APPLICATION NO.	FILING DATE	FIRST NAMED INVENTOR	ATTORNEY DOCKET NO.	CONFIRMATION NO.
10/807,311	03/24/2004	Atsushi Yoshimura	04329.3292	3790
22852	7590	11/29/2005		
FINNEGAN, HENDERSON, FARABOW, GARRETT & DUNNER LLP 901 NEW YORK AVENUE, NW WASHINGTON, DC 20001-4413				EXAMINER DIAZ, JOSE R
				ART UNIT 2815 PAPER NUMBER

DETAILED ACTION

2. Claims 9-16 are rejected under 35 U.S.C. 102(e) as being anticipated by Isaak (US Pat. No. 6,472,735 B2).

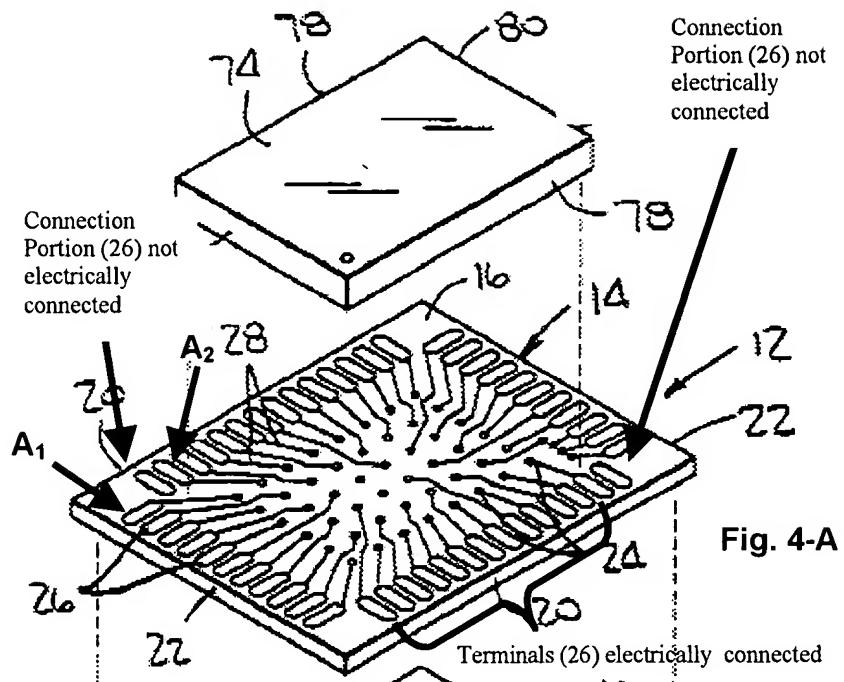
a first substrate (1st substrate 14) including an integrated circuit chip (1st chip 72)
[See figures 2 and 4-A, attached below], first connection terminals electrically connected to terminals of the integrated circuit chip [consider the terminals 26 electrically connected to the chip 72 as shown in Figure 4-A, attached below], and a first connection portion spaced from the first connection terminals and not electrically connected to any terminal of the integrated circuit chip [consider Connection Portions 26 not electrically connected to the chip 72 as shown in Figure 4-A, attached below];

a second substrate (2nd substrate 34) stacked on the first substrate [see figures 2 and 4-B, attached below] and including second connection terminals [consider the terminals 44 electrically connected to the chip 72 as shown in Figure 4-B, attached below] and a second connection portion spaced from the second connection terminals [consider the Connection Portions 44 not electrically connected to the chip 72 as shown in Figure 4-B, attached below]; and

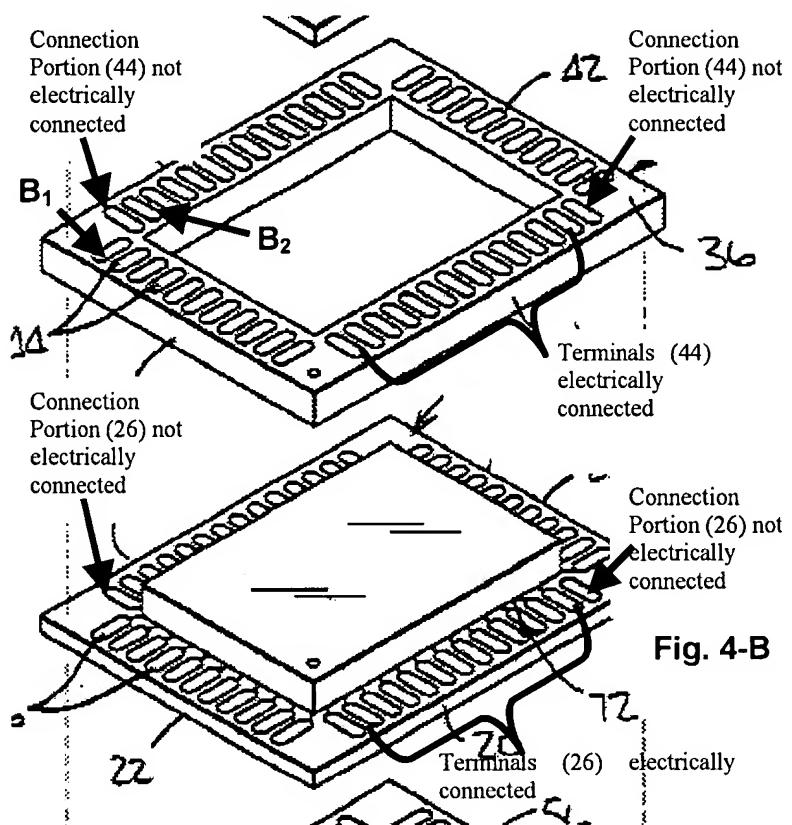
Regarding claim 12, Isaak further teaches that the first connection portion is a first dummy terminal provided between the first connection terminals adjacent to each other in a plane direction [consider Connection Portion 26 located between terminals A₁ and A₂ as shown in Figure 4-A, attached above], and the second connection portion is a second dummy terminal provided between the second connection terminals adjacent to each other in the plane direction [consider Connection Portion 44 located between terminals B₁ and B₂ as shown in Figure 4-B, attached above].

Regarding claim 13, Isaak further teaches that the first connection portion is a first dummy pad provided on the first substrate (14) [consider Connection Portions 26 not electrically connected to the chip 72 as shown in Figure 4-A, attached above], and the second connection portion is a second dummy pad provided on the second substrate [consider the Connection Portions 44 not electrically connected to the chip 72 as shown in Figure 4-B, attached above].

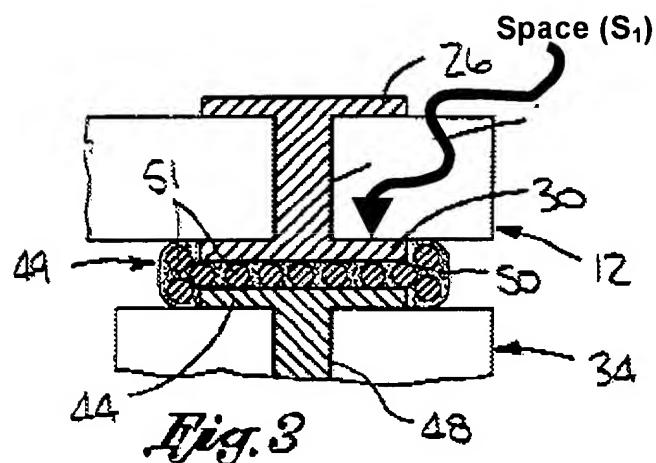
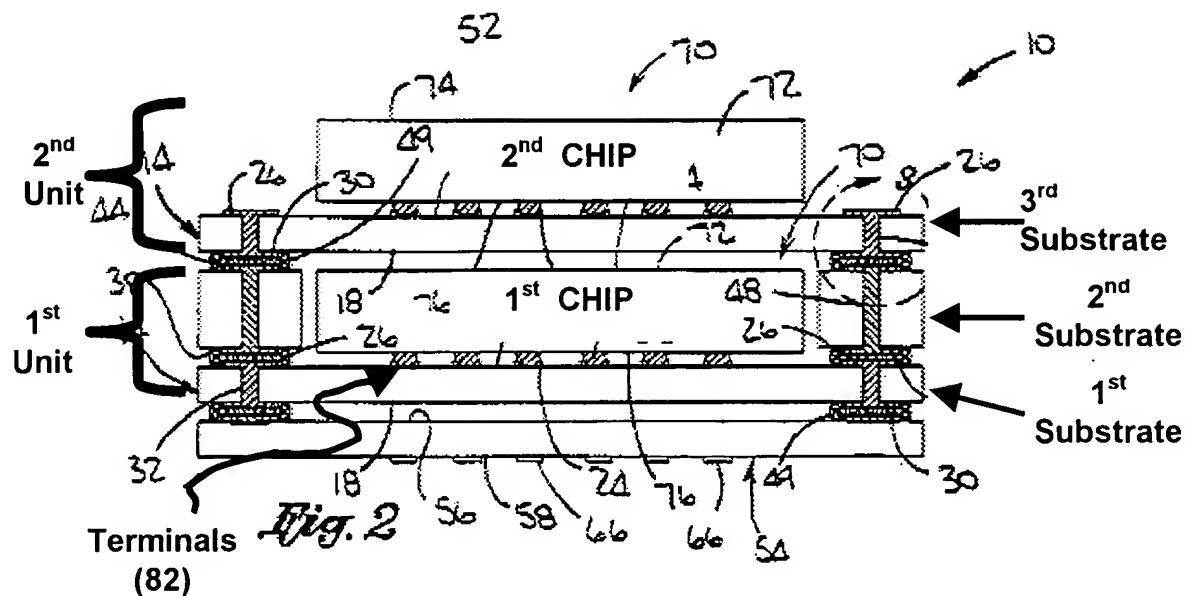
a metal material portion (30, 46, 51) provided between the first connection portion and the second connection portion [figures 2 and 3, attached below] and bonding the first connection portion to the second connection portion [figures 2 and 3, attached below] and not electrically connected to any terminal of the integrated circuit chip [consider the Connection Portions 26 and 44 not electrically connected to chip 72 in Figures 4-A and 4-B, attached above].

Regarding claim 10, Isaak further teaches a plurality of unit substrates (1st Unit and 2nd Unit as shown in fig. 2, attached above) that are stacked, each of the unit substrates being formed of the first (14) and second (34) substrates stacked (see fig. 2. and col. 8, lines 2-3. Please note that although it is not shown in the figures, Isaak, in col. 8, II. 2-3, further teaches that an additional second substrate 34 can be provided on the 3rd substrate].

Regarding claim 11, Isaak further teaches an adhesive sheet (49,50) interposed between the unit substrates (1st Unit and 2nd Unit) adjacent each other a stacking direction and bonding the unit substrates together (see figs. 2 and 3, attached above).
